Lexington Planning Board

Wednesday, August 13, 2025

952 Waltham Street - Village overlay site plan review

This letter is to advise the Town of Lexington's Planning Board that Apex Companies, LLC (Apex) has reviewed the revised materials submitted for the proposed townhouse-style development project located at 952 Waltham Street. The Applicant's submission includes the following documents:

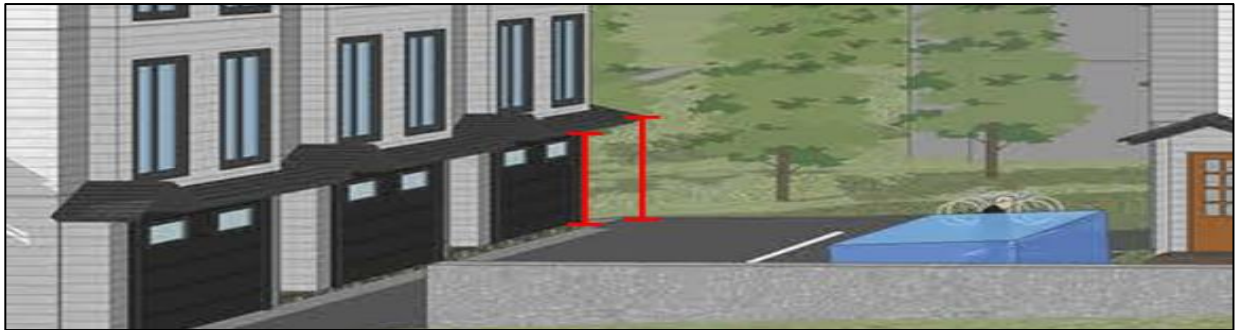
The Tree Mitigation Plan (L-102) last revised 7/21/2025 does not show all proposed locations of large deciduous trees from the Landscaping Plan (L-101).

No irrigation is proposed. The owners of the project will be required to maintain the the plantings in perpetuity. The Applicant's response to comments references only a 2 year period. Replacement in-kind for the life of the project will be a condition of any approval. Irrigation is recommend to assist with the long-term survival of plantings.

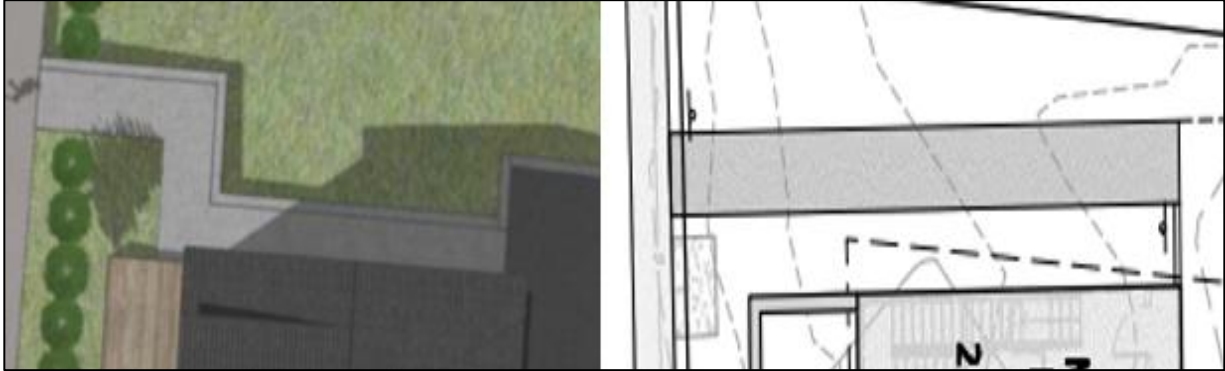
Setback distance is measured to the farthest projecting point of the building, including roof overhangs, and stairs. Applicant should confirm if setbacks are measured to the building foundation or the roof line. Steps to doors will also need to meet the minimum required setbacks. Updated elevations submitted on August 4 may need to be adjusted or verify that the second means of egress meets min. setbacks.

The garages on Units 1 – 3 are significantly taller than the garages on Units 4 – 8. What is the reason for the height difference? Can the garages on Units 1 – 3 be shortened to lower the building height?

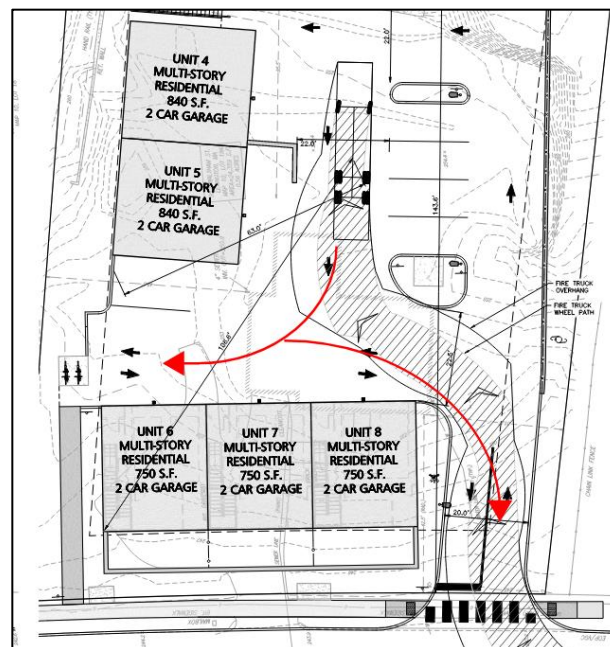
Building:

Building code requires that townhouses be sprinklered.
